Hatch Spent Fuel Pool Modification
Amendment 2

Page insertion instructions

Response to NRC questions contained in the NRC's letter of August 24, 1979

RESPONSE TO NRC QUESTIONS
CONTAINED IN THE NRC'S
LETTER OF AUGUST 24, 1979

Figure 7-2 Storage Cell Dimensions

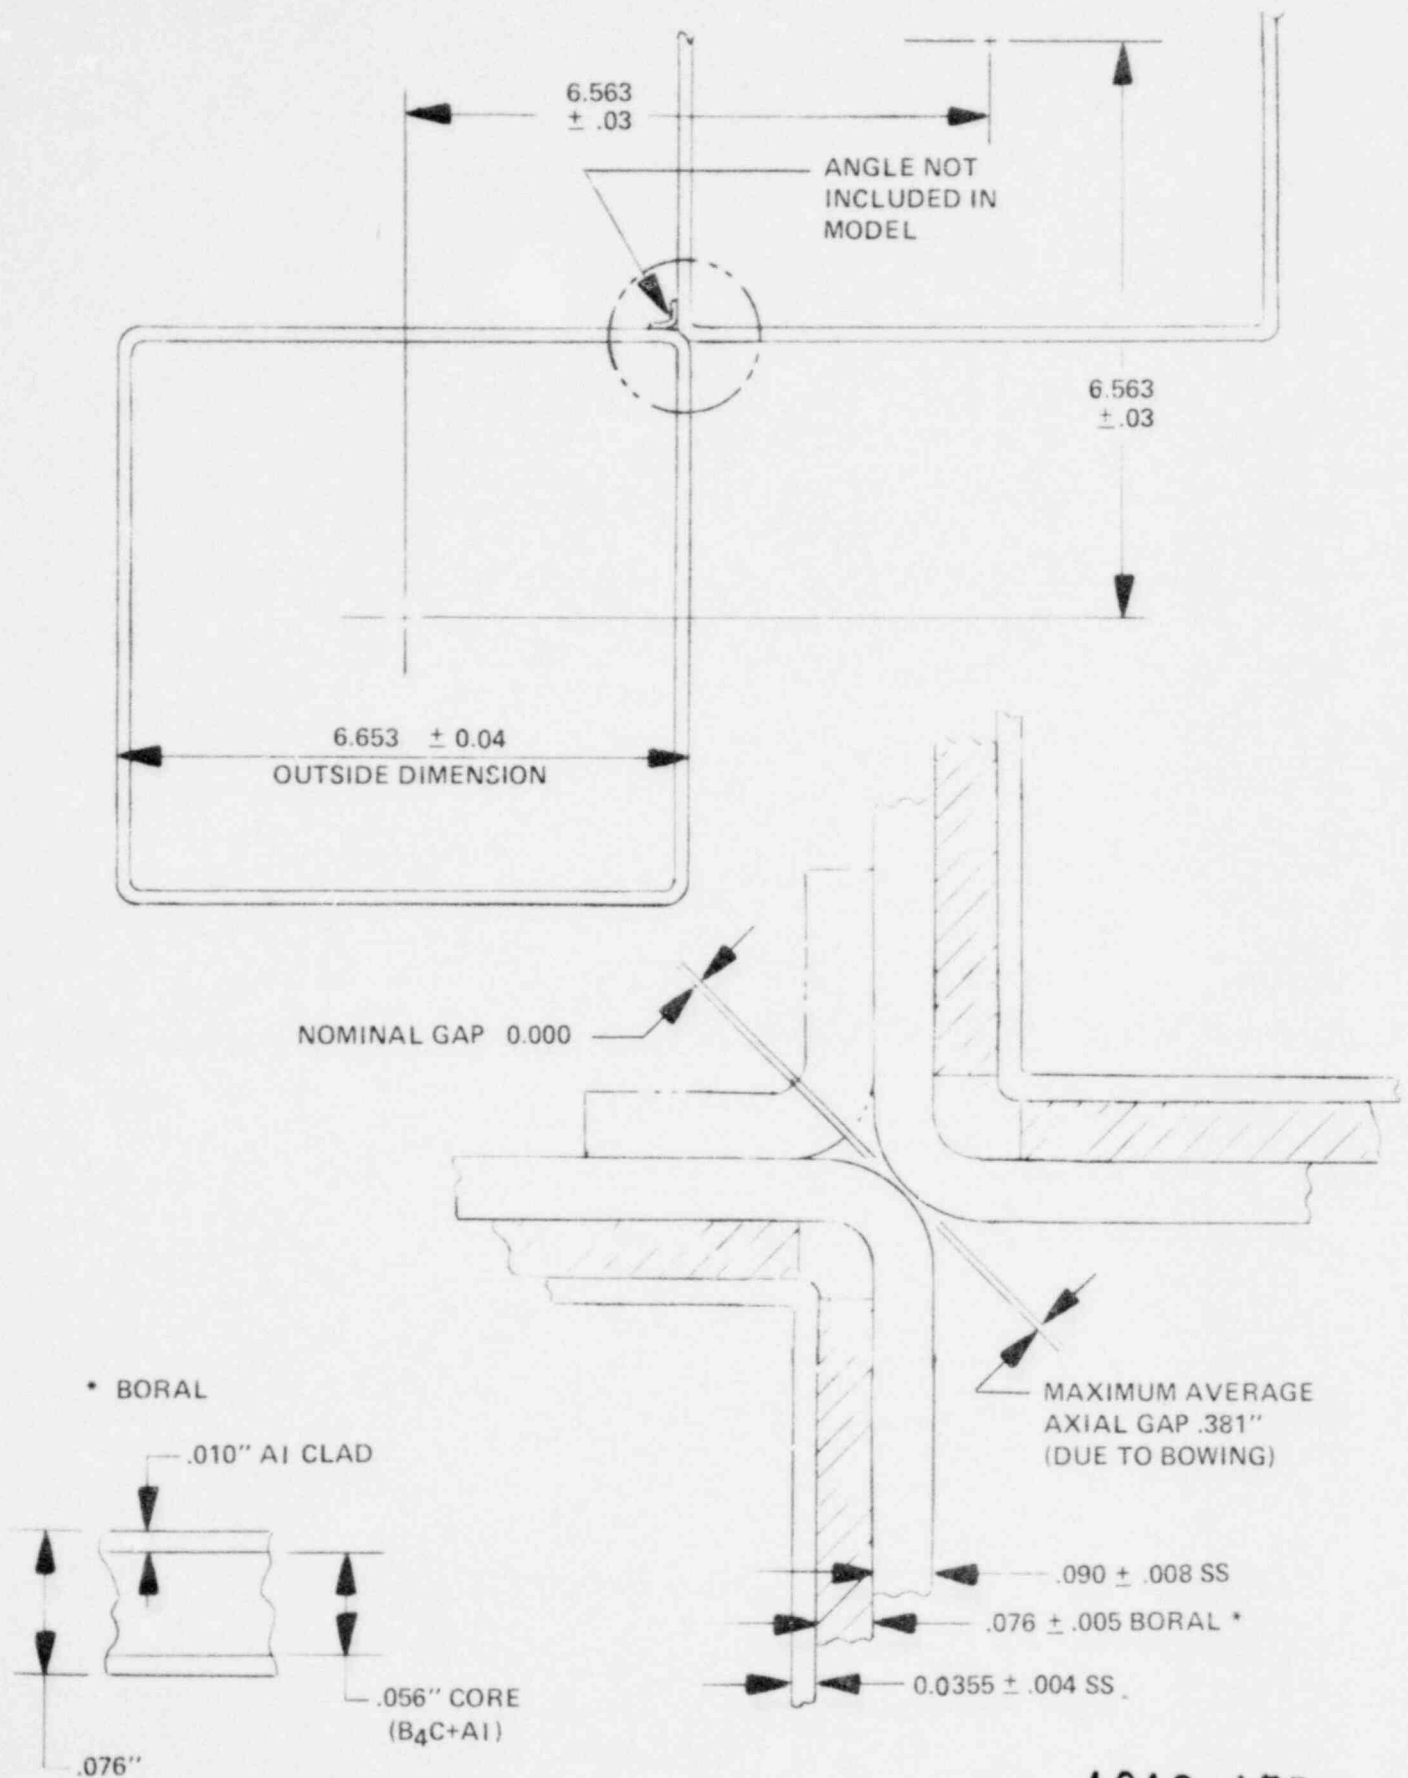
On page 7-3 of your submittal you state, "The results in Table 7-1 show that the nominal pitch (Case 2) has a higher k_{∞} result than the minimum pitch case (Case 6)." Since the statistical error bounds given on Table 7-1 do not preclude the opposite conclusion, and since all other calculations for similar storage lattices show the opposite to be true, provide a justification for this conclusion.

- d. Storage lattice pitch - An analysis was done using a minimum fuel pitch, represented by the storage tubes touching. Material tolerances in the tubes were taken to maximize the k_{∞} of the storage lattice. The result of the analysis is given as Case 6 in Table 7-1. A comparison of Cases 2 and 6 in Table 7-1 shows that within the statistical error bounds there is no significant difference between the results.

Item d. on page 7-3 has been restated to correct this discrepancy.

Figure 8-4 Realistic Fuel Pool Heat Loads and Temperatures 150 hr After Shutdown

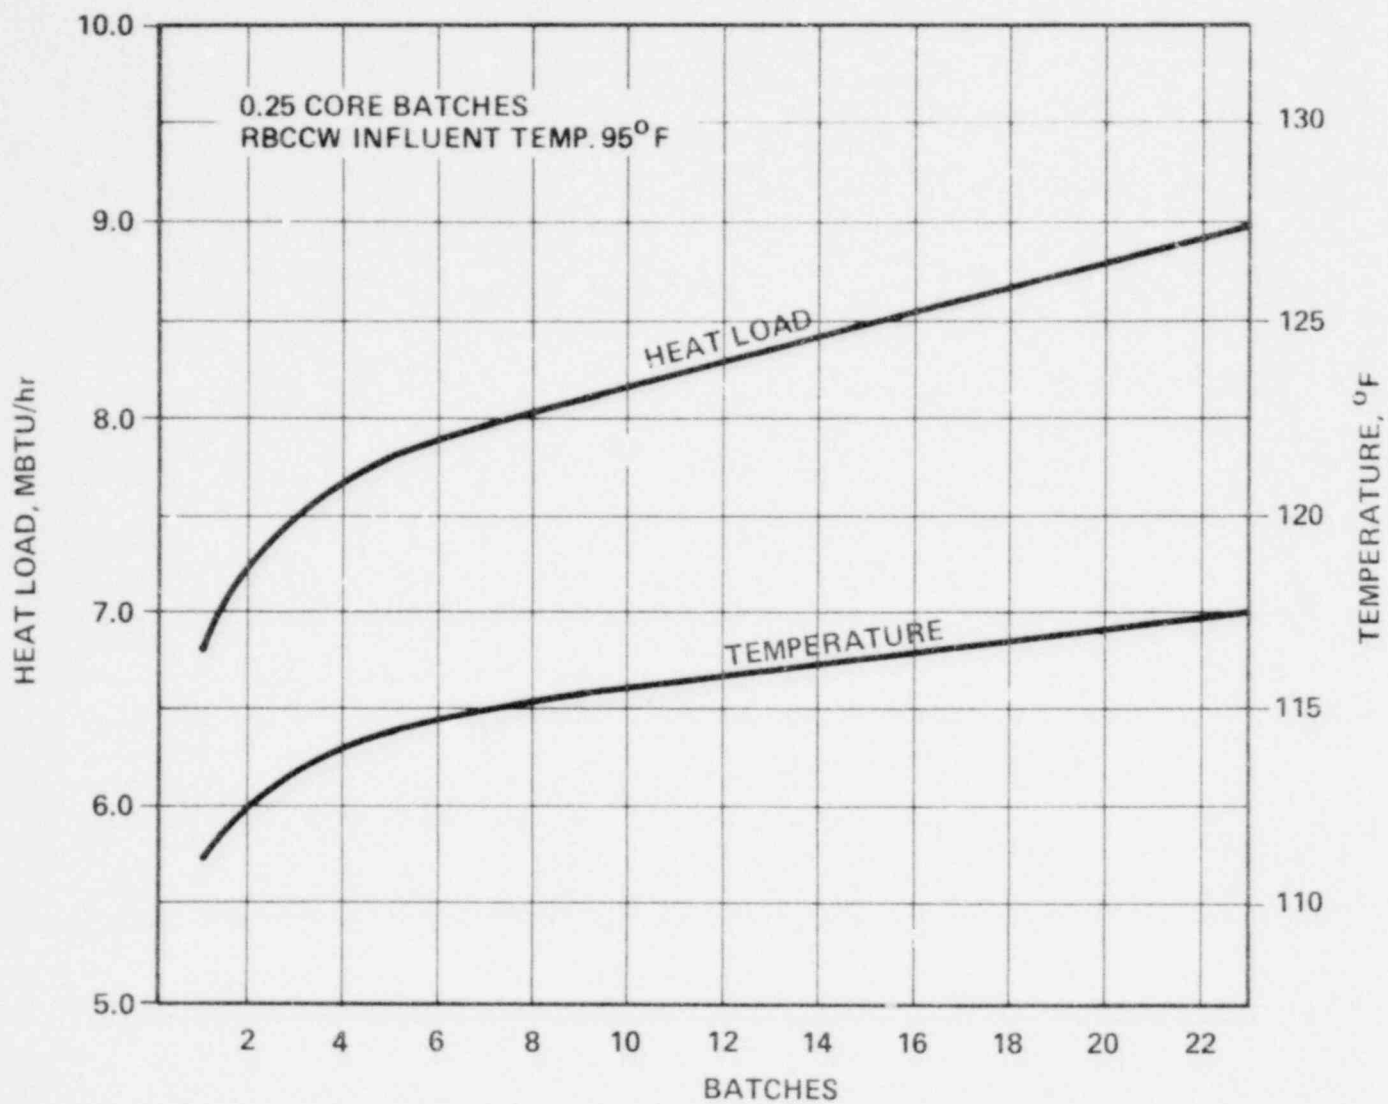
You stated in Section 8 of your submittal dated July 9, 1979 that the design pool bulk water temperature will be above the FSAR design value of 125°F during normal refuelings after the eighth refueling. If the actual expected value of the bulk water temperature, not the design value, may be above the 125°F under realistic conditions, discuss when this will occur during any refueling, for what period of time it will occur, the maximum value of the temperature and the effect of this on releases of radioiodine and tritium from the pools.

8.3.3 For each design condition analyzed in 8.3.2, completely utilizing the expanded spent fuel pool storage capacity, the present SFPC systems or a single train of the RHR (for the full core offload condition) are capable of maintaining pool water temperatures less than the design maximum temperature of 150°F. Considering the conservative assumptions used in the calculations and past operating experience, the actual temperatures for each condition are expected to be lower than those calculated and described above. A reanalysis of the spent fuel pool heat loads and bulk pool water temperatures was performed for the normal and refueling conditions assuming realistic values of 80 percent plant availability, RB/CW system influent temperature of 95°F to the spent fuel pool heat exchangers, and quarter core discharge batches. The peak bulk pool water temperatures were calculated to be less than 123°F as shown in Figures 8-4 and 8-5. Therefore, there will be no additional releases of radioiodine or tritium from the pool, since the pool temperatures are not raised beyond their original design limit of 125°F.

The response has been incorporated into Section 8.3.3.
